Access Compliance Report

Public Rights-of-Way

Intersection ID: 20407	Main Street: CAMERON_VALLEY_PY	Cross Street: COLTSGATE_RD	Location: NW
ADA ID: F5FB14548B3C	Ramp Type: PerpDiag	Initial Pass/Fail: Fail	Overall Compliance: No
		Severity Score: 12.5

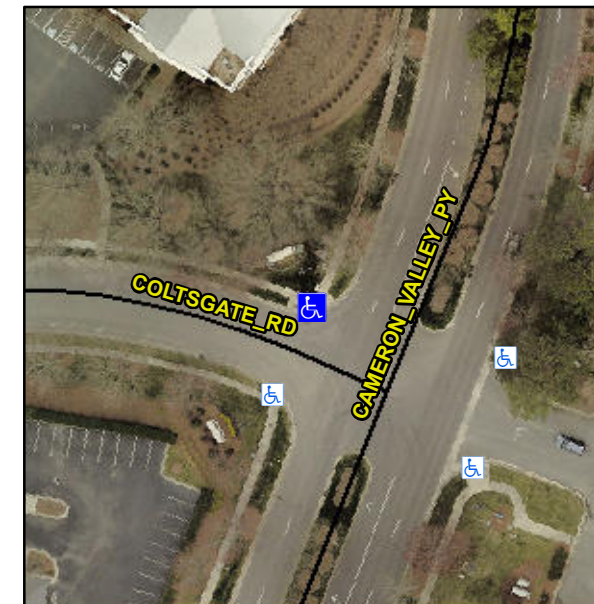
R304.2.2

Compliance	Description	Data	Compliance	Description	Data
N/A	Ramp Length (in)	61.0	No	Ramp Slope (%)	9.8
Yes	Ramp Width (in)	48.0	Yes	Ramp XSlope (%)	1.8
N/A	Flare Type LT	N/A	N/A	Flare Type RT	N/A
N/A	Flare Slope LT (%)	N/A	N/A	Flare Slope RT (%)	N/A
N/A	Flare Traversable LT?	N/A	N/A	Flare Traversable RT?	N/A
N/A	Landing Length (in)	N/A	N/A	DWS Provided?	N/A
N/A	Landing Width (in)	N/A	N/A	DWS Contrast?	N/A
N/A	Landing Slope (%)	N/A	N/A	DWS Length (in)	N/A
N/A	Landing X Slope (%)	N/A	N/A	DWS Full Width?	N/A
N/A	Landing Curb? (Y/N)	N/A	N/A	DWS Offset (in)	N/A
N/A	Shared Landing?	N/A			
N/A	Gutter Ponding?	N/A	N/A	Gutter Slope (%)	N/A
N/A	Gutter Lip Ht (in)	N/A	N/A	Gutter X Slope (%)	N/A
N/A	Painted X Walk1?	No	N/A	Painted X Walk2?	No
	X Walk 1 Direction	To SW		X Walk 2 Direction	To SE
N/A	X Walk 1 Width (in)	N/A	N/A	X Walk 2 Width (in)	N/A
	X Walk 1 Slope (%)	2.5		X Walk 2 Slope (%)	0.0
	X Walk 1 X Slope (%)	0.1		X Walk 2 X Slope (%)	4.4

Remove & Replace Curb Ramp With Two New Directional Ramps or Equivalent.
